A330 APPU ATA 27

APPU PN: 9028A0005-01

APPU – Ratcheting: Recap

pre-mod connector gasket

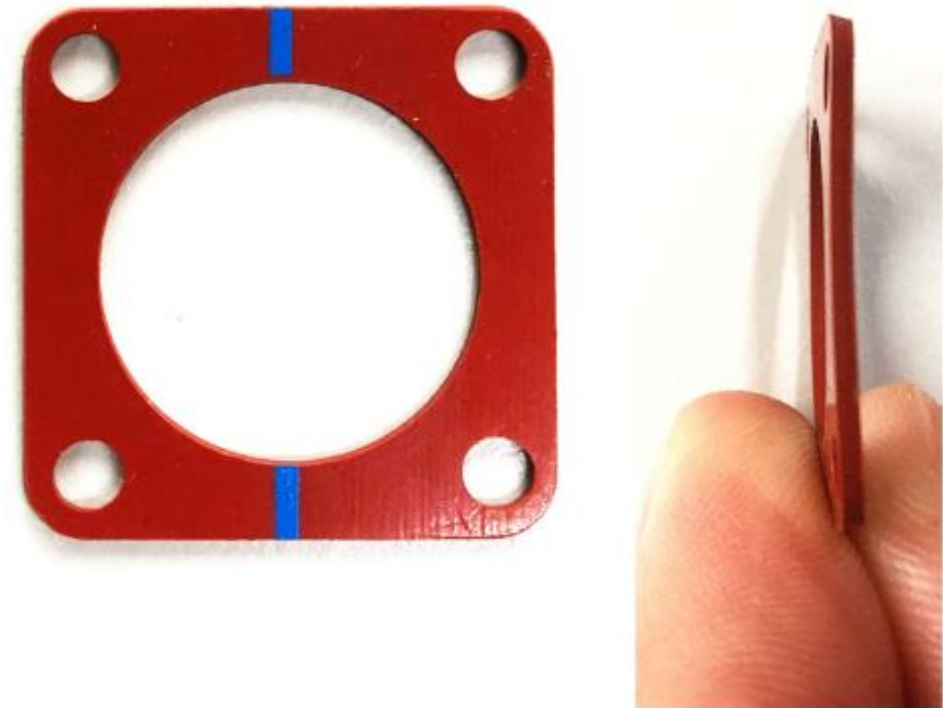
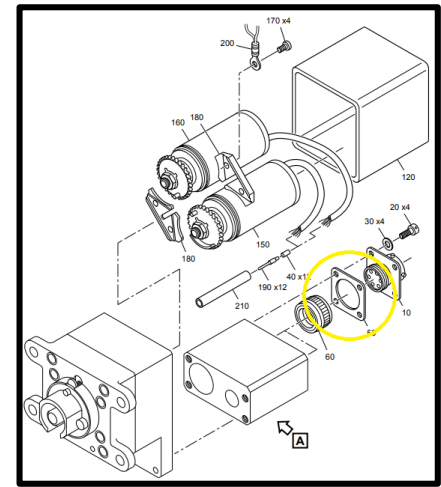
- Flaps locked during approach on A/C delivered since DEC 2016
- ECAM warning F/CTL FLAPS LOCKED
- Root Cause:
 - Seal of (black anodized) connector insufficient
 - Low temp conditions: moisture inside harmonic drive freezes → ratcheting
 - Ratcheting causes offset between electrical vs. mechanical position → asymmetry

post-mod connector gasket
